# CITY OF ALBUQUERQUE

RE: **Lot 3 Block 9 Unit 18 SAD 228**  
**7900 Aguilar NW**  
**Volcano Cliffs Subdivision**  
**Grading and Drainage Plan**  
**Engineers Stamp Date 10/12/2020 (D10D003I3)**

Based upon the information provided in your submittal received 10/14/2020, this plan is approved for Grading Permit.

ENGINEER'S SEAL	LOT 3 BLOCK 9 UNIT 18 VC 7920 AGUILAR ST	DRAWN BY DEM
DAVID SOULE REGISTERED PROFESSIONAL ENGINEER 10/12/20	GRADING AND DRAINAGE PLAN	DATE 10-11-20
		LOT 3 BLOCK 9 UNIT 18 VC DWG
		SHEET # C1
		JOB #

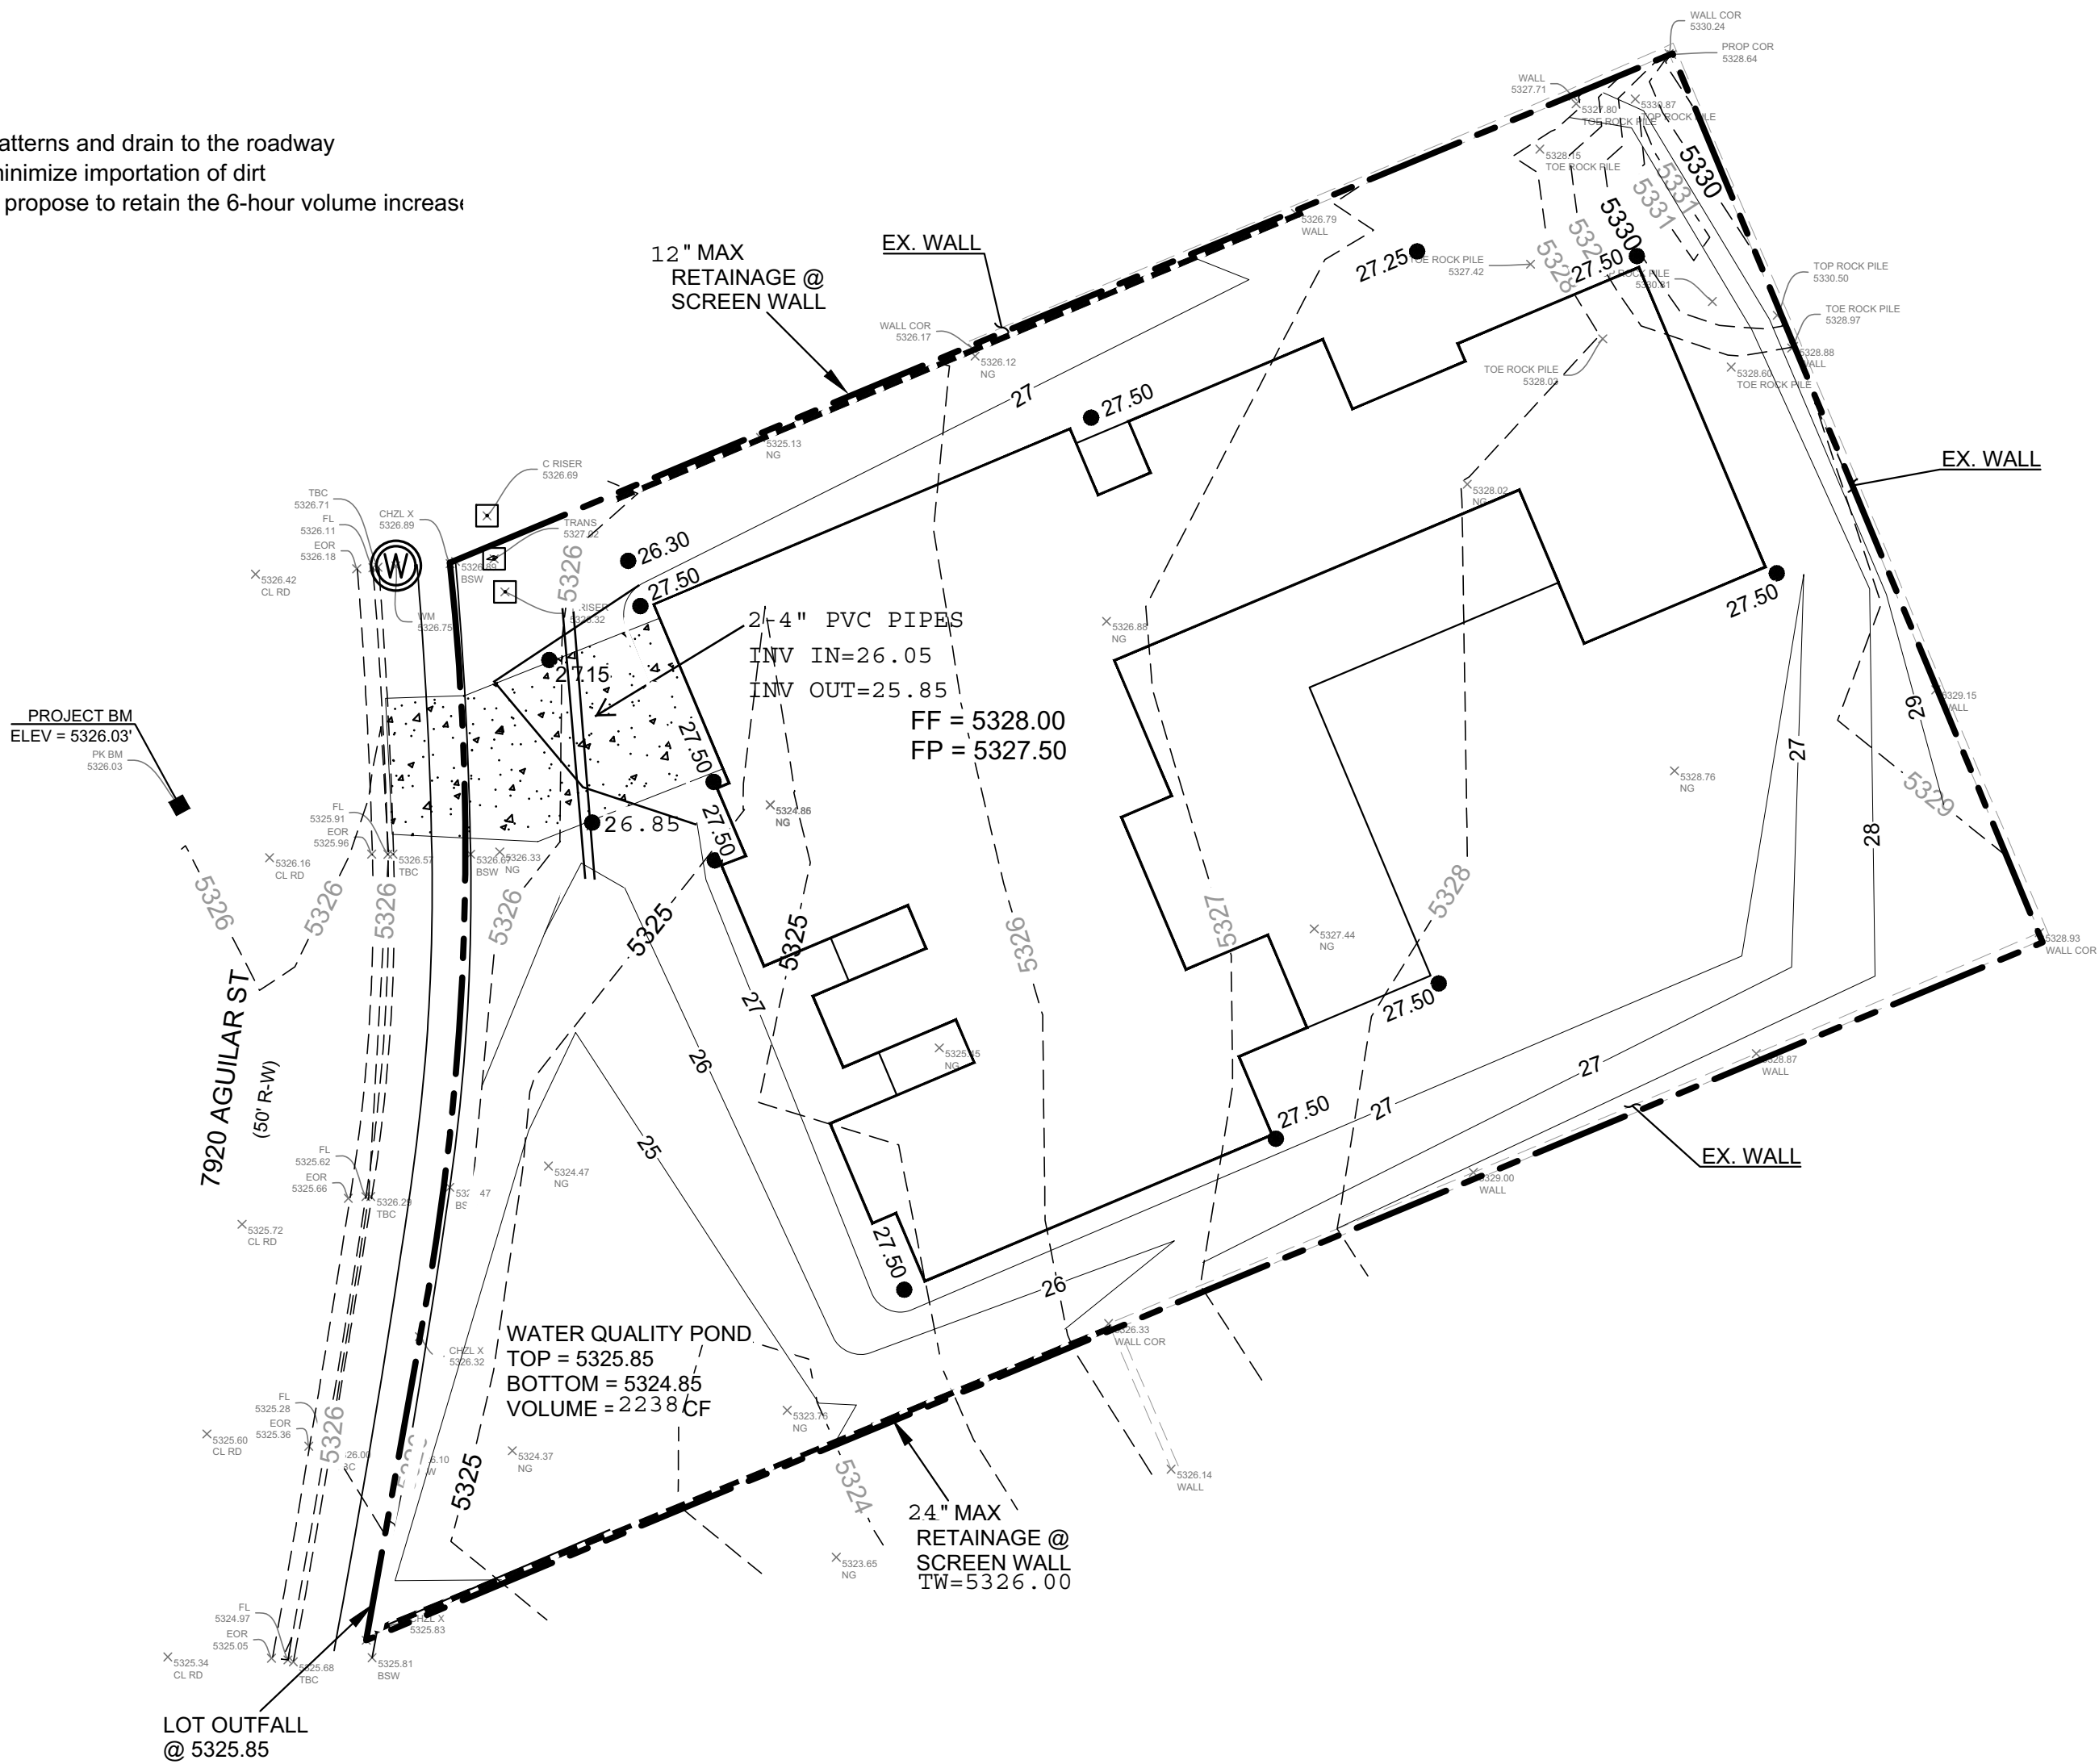
**Prior to Building permit approval a Pad Certification will be required, provided by the Engineer or a registered Land Surveyor.**

**Advise the owner contractor not to use dirt as a ramp to climb the curb, use lumber or crusher fines for this purpose.**

Reiterate to the Owner/Contractor that a separate permit for a garden/retaining wall must be obtained with the approved G&D plan and Pad Certification. Also, if a swimming pool is to be placed the grading and drainage plan will change and will need to be resubmitted.

**Prior to Certificate of Occupancy release, Engineer Certification per the DPM checklist is required.**
